Serial No. 05-307A
NLOS/PRW Rev. 0
Docket No. 50-336
License No. DPR-65

DOMINION NUCLEAR CONNECTICUT, INC.
MILLSTONE POWER STATION UNIT 2
SUPPLEMENT TO PROPOSED REVISION TO TECHNICAL SPECIFICATIONS
REACTOR COOLANT SYSTEM HEATUP/COOLDOWN LIMITS(LBDCR 05-MP2-003)

SUPPLEMENT TO PROPOSED REVISION TO TECHNICAL SPECIFICATIONS (LBDCR 05-MP2-003) REACTOR COOLANT SYSTEM HEATUP/COOLDOWN LIMITS

Millstone Unit 2 Reactor Coolant System
Heatup Limitations for Up to 20 EFPY
Figure 3.4-2a

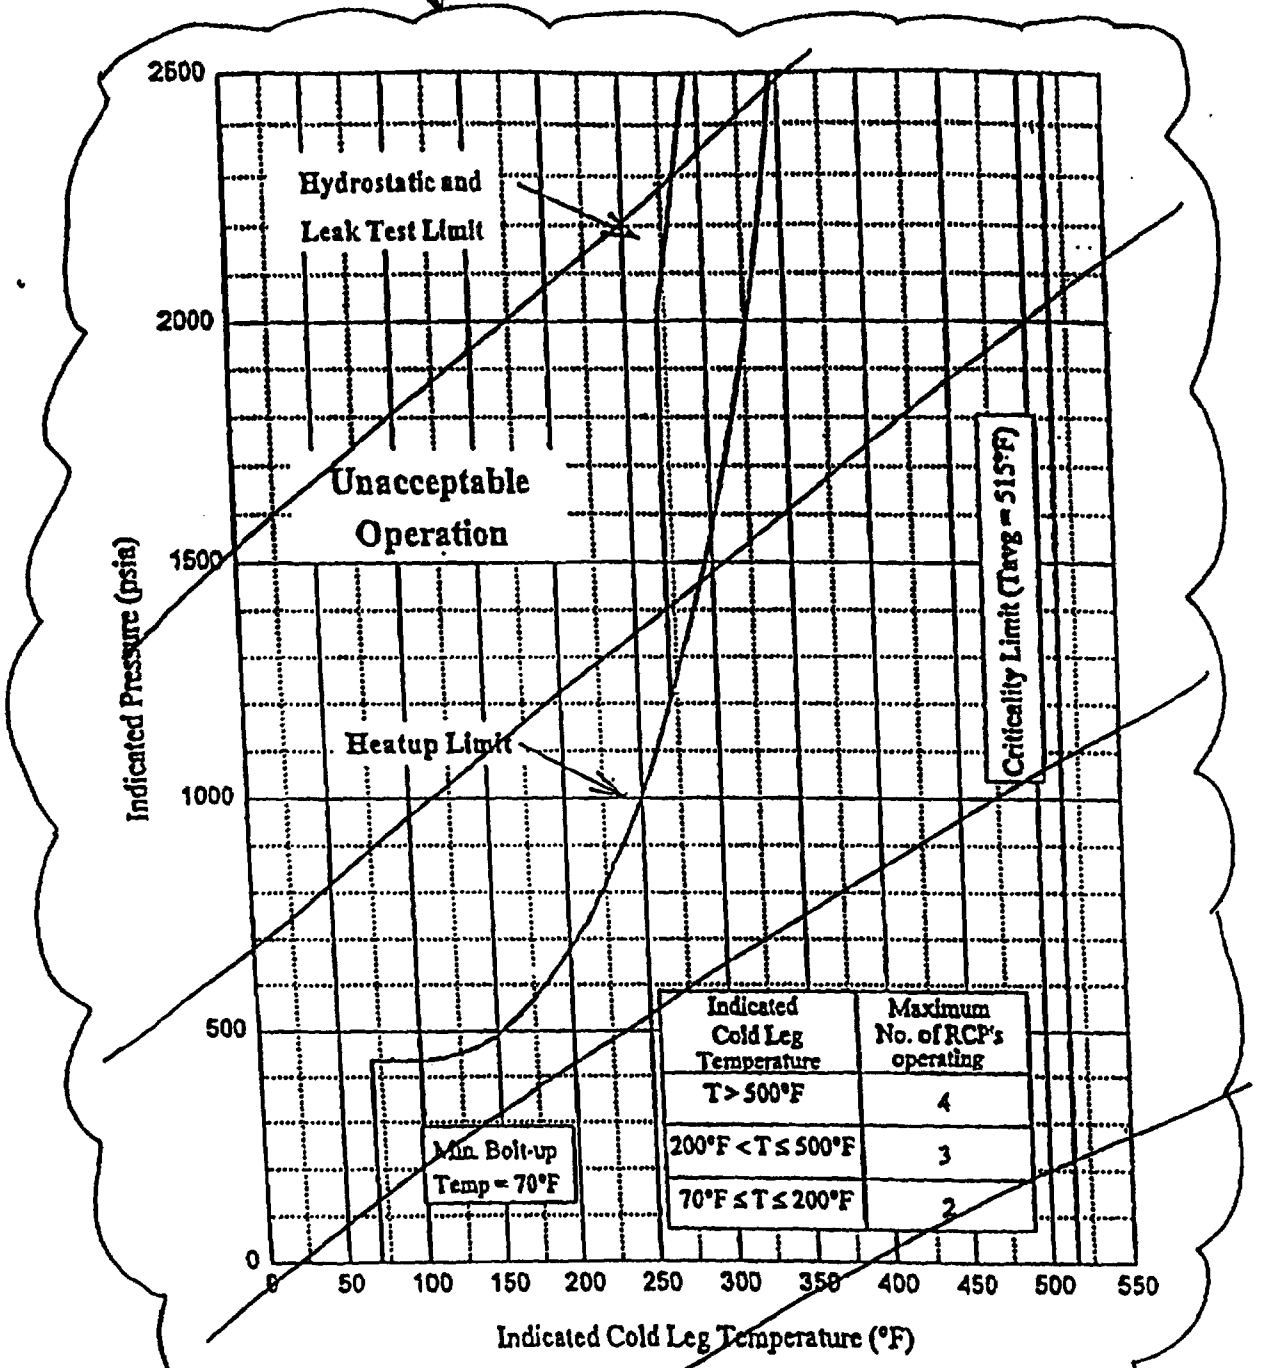
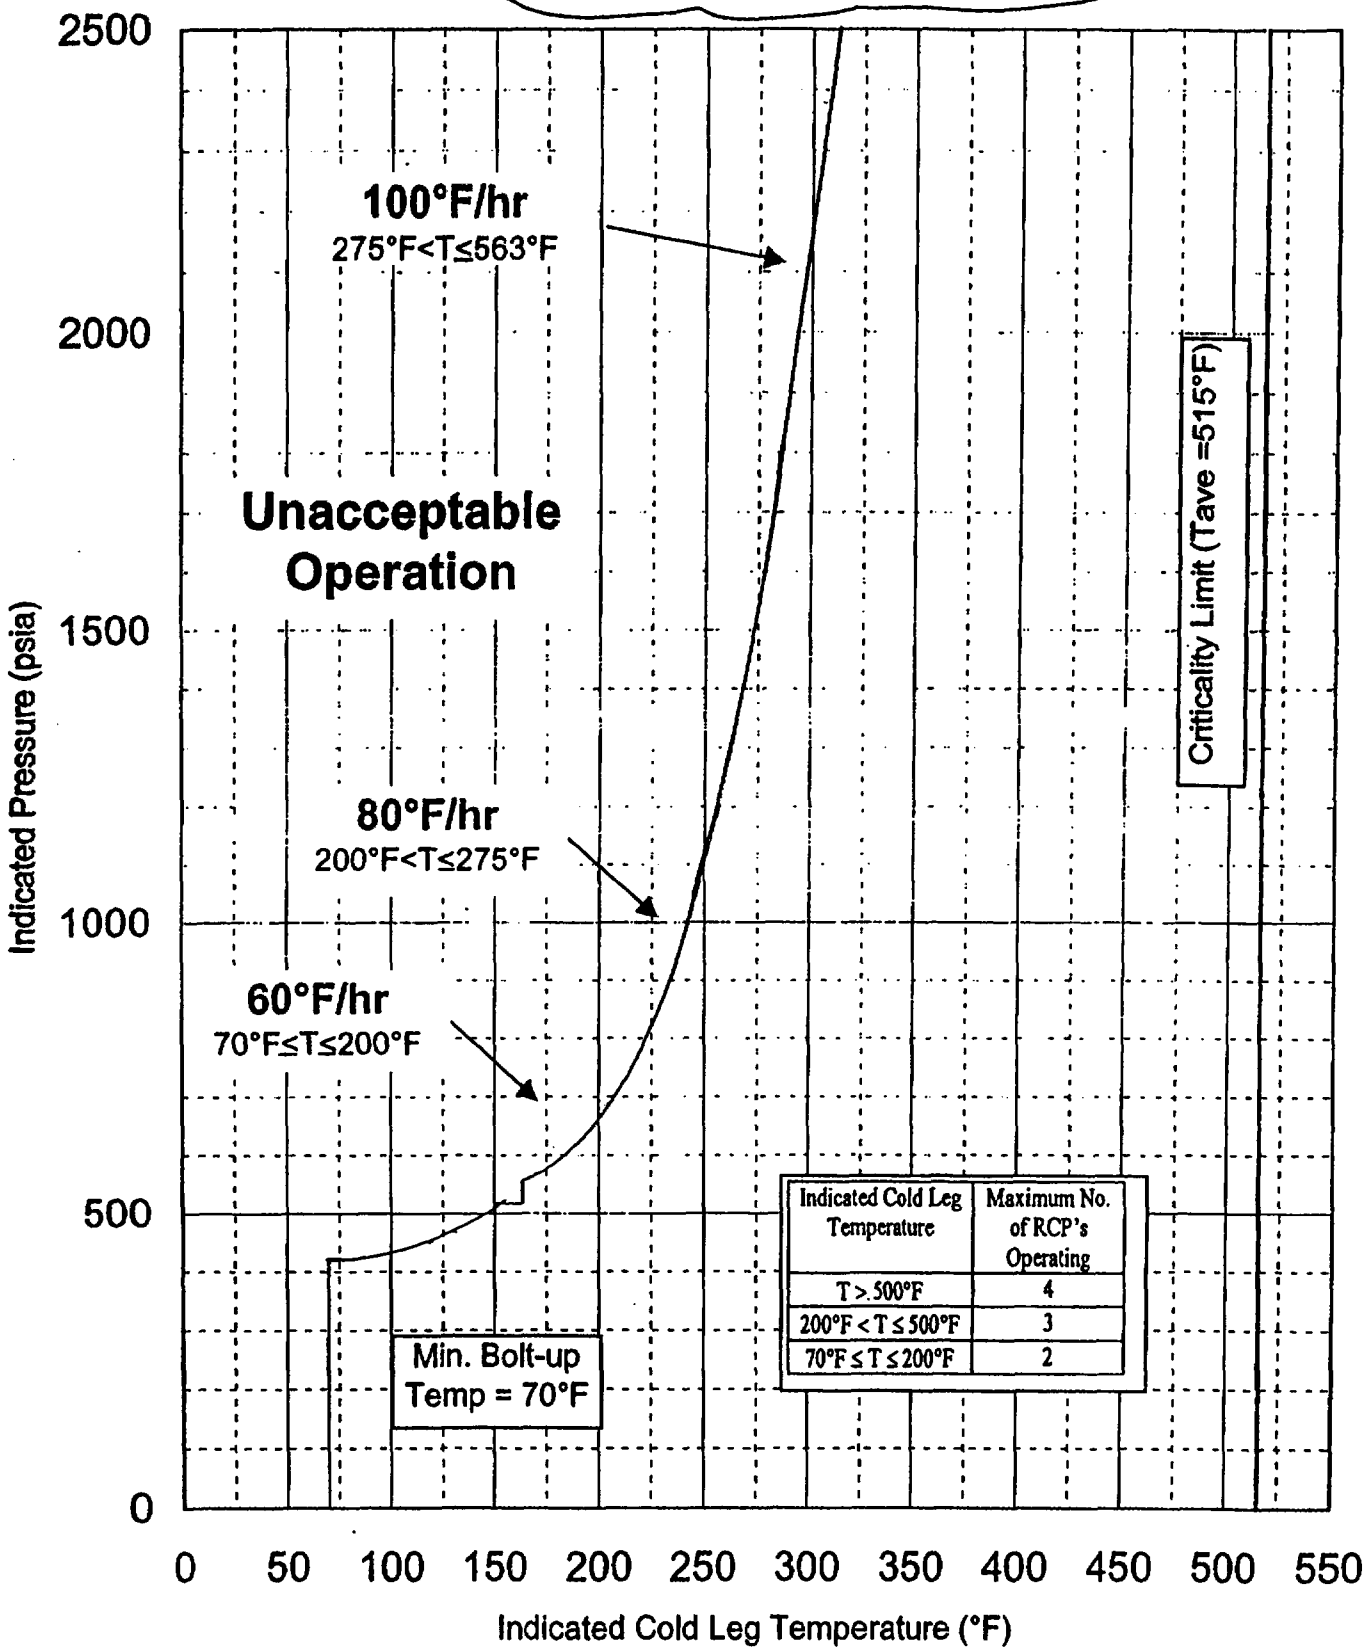
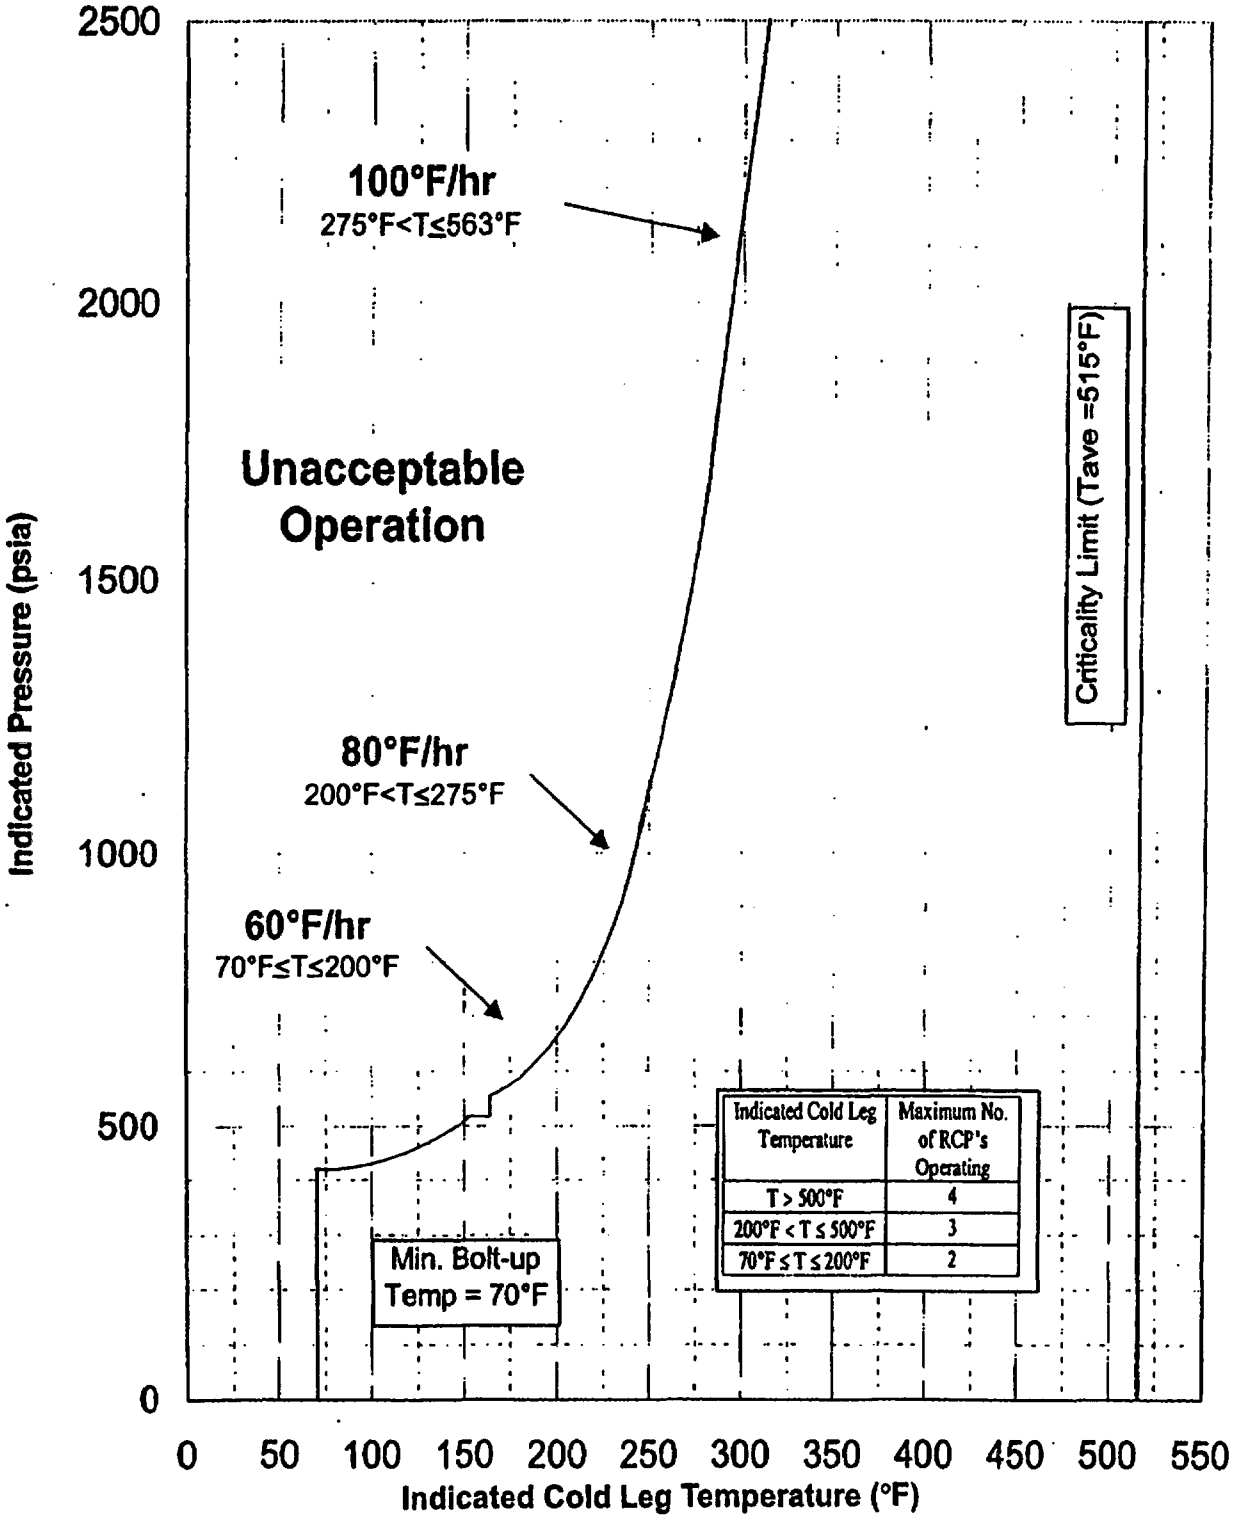
1. Figure 3.4-2a will be replaced with a new curve valid up to 54 EFPY. Figure 3.4-2a addresses plant heatup and is currently valid up to 20 EFPY. The heatup rate limits contained in Table 3.4-2, have been changed in conjunction with the new curve.

Figure 3.4-2a addresses plant heatup and is currently valid up to 20 EFPY. Figure 3.4-2a will be replaced with a new curve valid up to 54 EFPY. The associated heatup rate limits contained in Table 3.4-2 have been changed as a result of the new analysis. The new rate limits have been simplified and updated for greater consistency between heatup and cooldown. The hydrostatic and leak test limit are now administratively controlled by the heatup limit and not explicitly shown on the figure.

2. Figure 3.4-2a has been modified to remove the hydrostatic and leak test limit line. The hydrostatic and leak test limit will now be administratively controlled by the heatup limit. Administratively limiting hydrostatic and leak test to the heatup limit provides additional margin to the Appendix G requirements. Table 3.4-2 has been modified to remove the Inservice Hydrostatic and Leak Testing item and to add a note indicating heatup limitations also apply to hydrostatic and leak test conditions. The requirement to remain isothermal (rate ≤ 5°F / hour) for 1 hour prior and during hydrostatic and leak test above the heatup curve is no longer needed as operation above the heatup curve is no longer allowed. These proposed changes will have no adverse effect on plant safety.

Millstone Unit 2 Reactor Coolant System Heatup Limitations for up to 54 EFPY
